Request for Advice

Application No. **SSD-98068713**
Property Address **65 Muston Street, Mosman**

Thank you for your correspondence dated 31 March 2026 inviting Mosman Council (Council) to comment on the exhibition (EXH-110925988) of State Significant Development (SSD) Application No. SSD-98068713 for demolition of the existing building and ancillary structures, tree removal; and, the construction of a part 8 and part 10-storey residential flat building development comprising 13 residential apartments (including 3 in-fill affordable housing units), rooftop communal space, communal wellness centre, 29 car parking spaces (including 3 visitor spaces) over 2.5 levels of basement parking, and associated civil and landscaping works.

Muston Street Interface

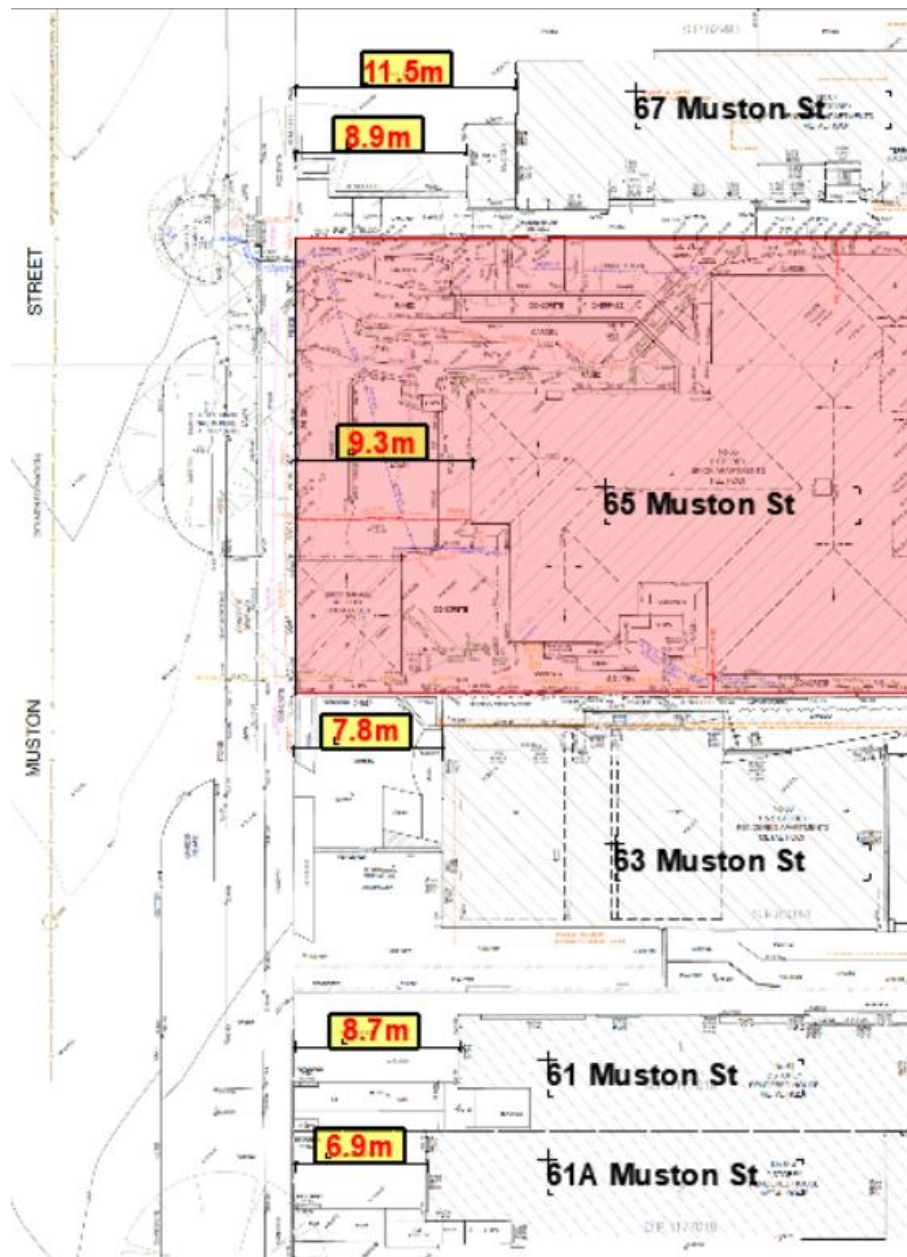
In reference to Part 4.2 'Siting and scale' of the Mosman Residential Development Control Plan (MRDCP), the proposed development should demonstrate adequate consideration of the following:

- Objective O4 aims "*To have front setbacks complementing existing setbacks in the street.*"
- Planning Control P3 states "*If a new development is to take place in a street with an established pattern of development, new buildings should be setback a similar distance from the street.*"

Muston Street is currently characterised by generous landscape setbacks that vary between 11.5m and 6.9m. A marked-up extract of the survey plan is provided herein to establish the pattern of front setbacks for adjoining and adjacent development.

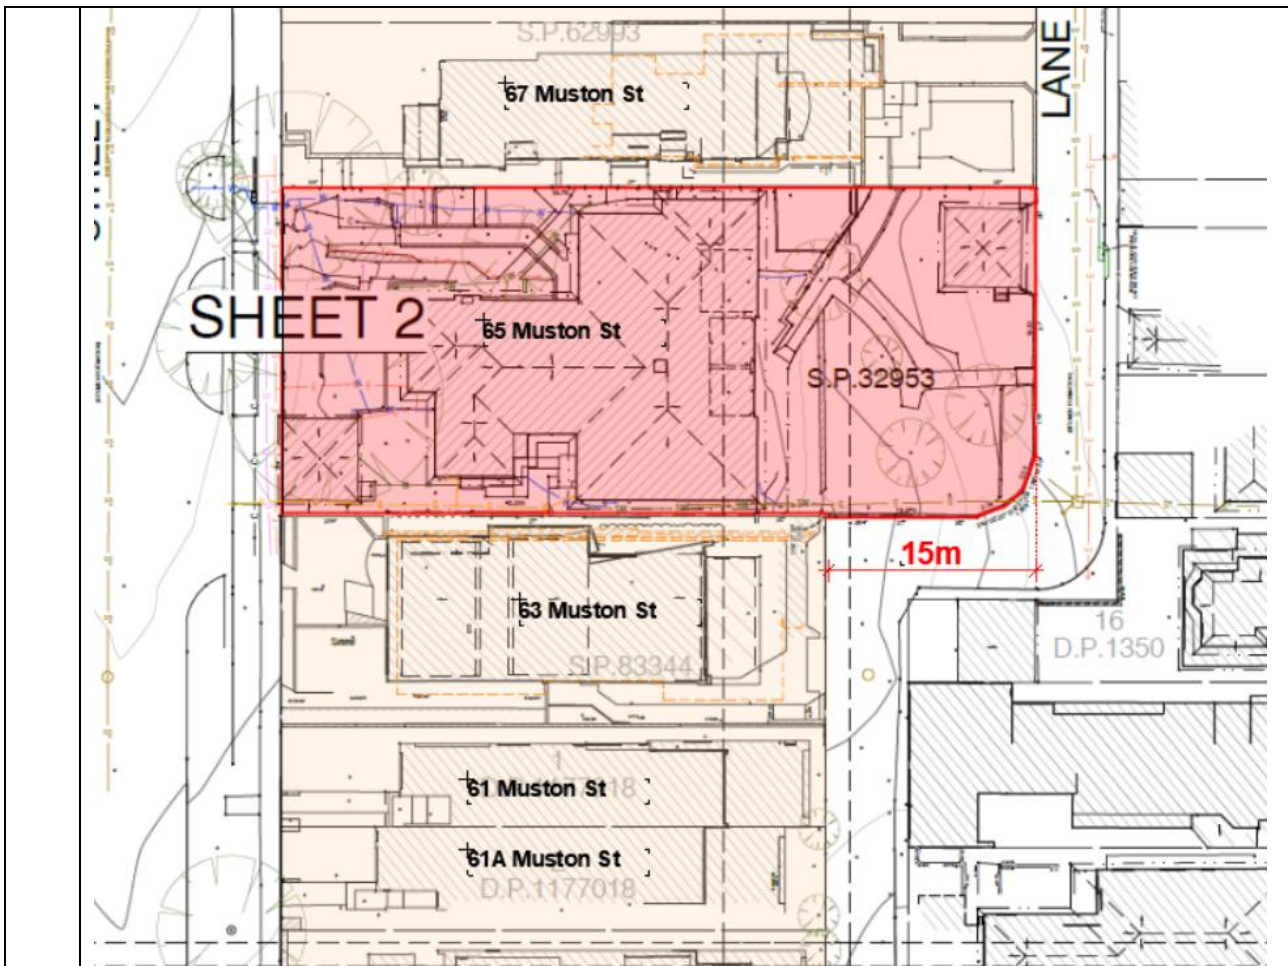
Redan Lane is a narrow lane currently utilised to provide vehicle access to residential properties, fronting Redan Street and Muston Street. As the surrounding area develops in response to increased densities provided by State Planning Controls, the use of this lane by pedestrians (seeking access to the Town Centre) and vehicles will significantly increase.

The combination of both significantly increased pedestrian and vehicular traffic (as both sides of the lane develop) is a safety concern. A cohesive strategy must be developed to accommodate vehicle access and servicing (particularly waste collection) whilst providing a safe and pleasant environment for pedestrians. To achieve this goal, consideration should be given to on-site waste collection with forward truck ingress and egress. This may not be a practical solution for smaller sites, where a layby to accommodate waste collection trucks may be considered. To improve pedestrian safety consideration should be given to either the introduction of a dedicated pedestrian path or the development of the lane as a shared way.

The sharp turns within the lane also create a potential traffic safety issue, that will increase as densities within the street increase. The proposed building on the subject site should be set back (south-east corner of the site) from the lane to accommodate sight-lines between vehicles, as outlined by Council's Transport Engineering Consultant in Item 10 'Transport, Access and Parking'.

Extract of survey plan with mark-up (Source: Drawing 24328Edetail, CMS Surveyors)

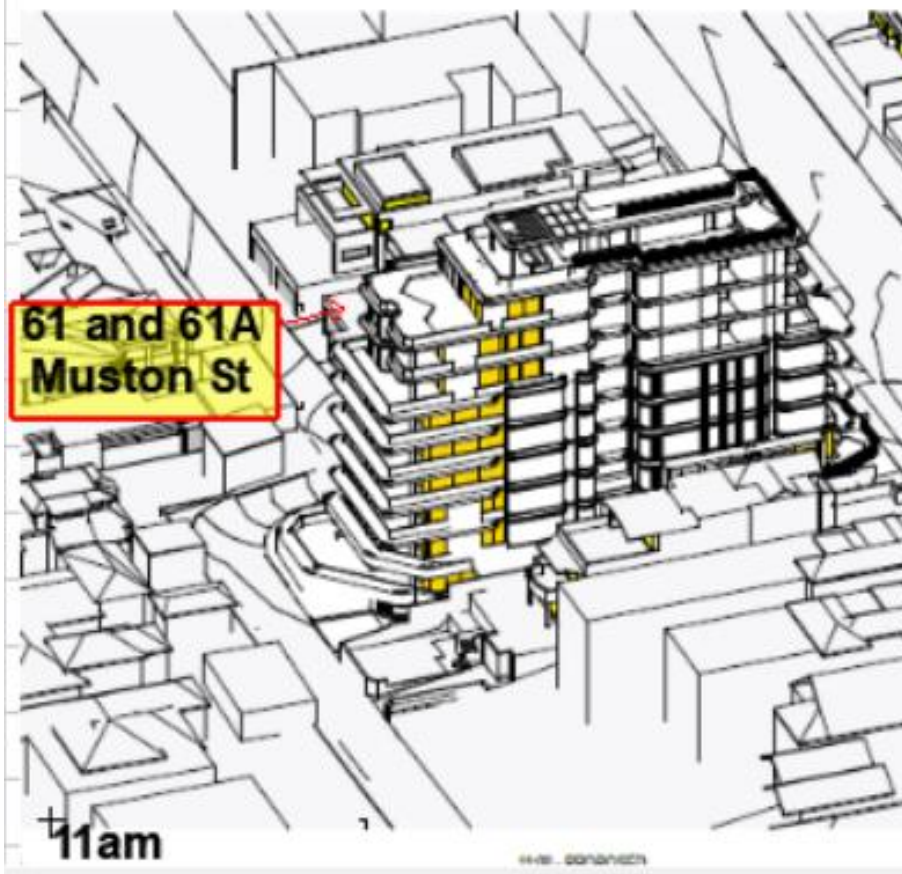
When much larger scale buildings are considered in this context the impact of the lot configuration must be taken into account. A future built form on the subject site must be developed to minimise its impact upon the amenity of southern neighbours and accommodate an equitable and amenable pattern of development on neighbouring sites. It is a concern that the current proposal prevents solar access to the neighbouring sites immediately to the south.

Height

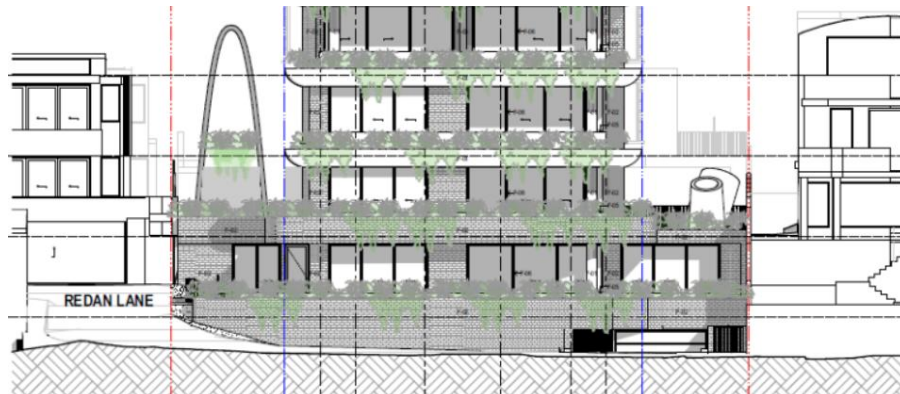
The current proposal is 3.08m above the 28.6m maximum building height non-discretionary development standard. No convincing rationale has been provided to justify why it is desirable or necessary to contravene the height standard.

It is also noted that the proposal provides 3.5m floor to floor heights on all of the eight residential levels proposed. This is 300mm in excess of the industry standard of 3.2m, which will allow ADG compliant ceiling heights (2.7m) to be accommodated. If industry standard ceiling heights were applied, the building could be lowered by up to 2.4m.

Further refinement of the proposed building form is recommended, to provide an improved contextual response, and to ensure the proposed development does not present as an over-development of the site.

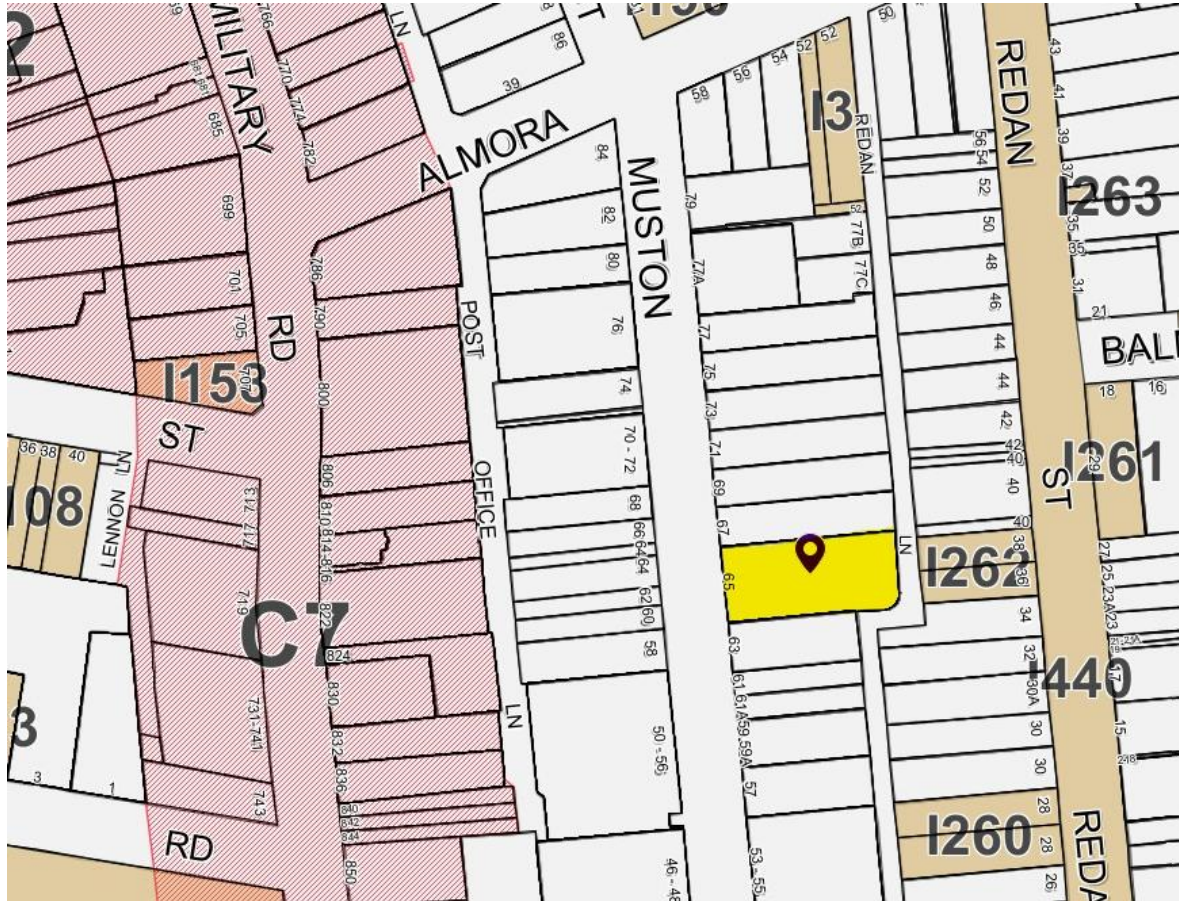
The proposed development is located within the vicinity of several heritage items including:

- Item I262 - 'Pair of semi-detached houses', 36-38 Redan Street (directly to the east)
- Item I440 - 'Divided Road', Redan Street (to the east)
- Item I3 - 'House', 52 Almora Street (to the north)
- Item I260 - 'House', 28 Redan Street (to the south)

The proposed building is substantially higher than surrounding development, including the identified heritage items. It will be a much higher structure that will be highly visible within the setting of the items. It will particularly be visible in views of the heritage item at 36-38 Redan Street. The applicant's Visual Impact Assessment has omitted to provide view studies of the proposal within views of the heritage items in the vicinity.

The proposal is an inappropriate response to the adjacent heritage listed building at 36-38 Redan Street and heritage items within the vicinity of the site. In this regard, the application has not provided adequate justification or mitigation measures for these impacts, and as such, the proposal is considered inconsistent with relevant heritage conservation objectives and planning controls set out in Clause 5.10 'Heritage conservation' of MLEP and Part 5.6 'Heritage conservation' of MRDCP.

Extract from Drawing A-711-010 documenting areas included in the 3m x 3m deep soil zones (Source: Studio Johnston)

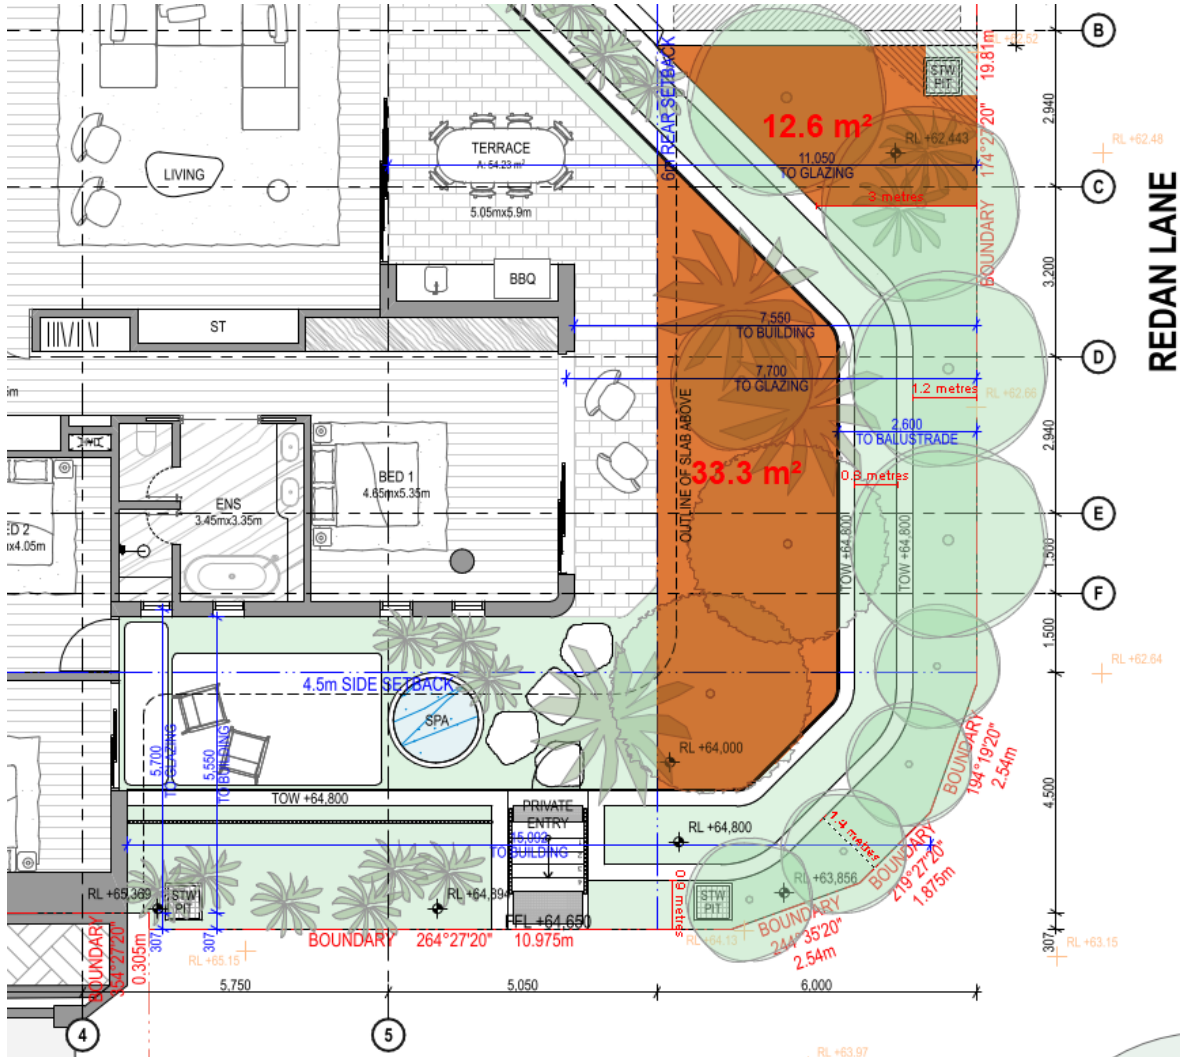
The applicant's deep soil calculations state a deep soil zone of 10.1% (135.73sqm). The methodology undertaken for the calculation of deep soil fails to comply with the above definition as it includes areas that do not meet the minimum 3m x 3m (9sqm area) requirement. More specifically,

- The garden area adjacent to the Redan Lane frontage includes retaining walls in response to level changes and site topography and does not meet the 3m dimension (in every horizontal direction). This area is documented as contributing 86.27sqm of deep soil which is incorrect.
- The garden bed adjacent to the Muston Street frontage and water meters, does not meet the 3m dimension (in every horizontal direction). This area is documented as contributing 9.15sqm of deep soil which is incorrect.

Having regard to the above, Council has calculated the deep soil zone to be 6.4% (86.21sqm) which is below the minimum 7% (93.94sqm) requirement of the Tree Canopy Guide for LMR Housing.
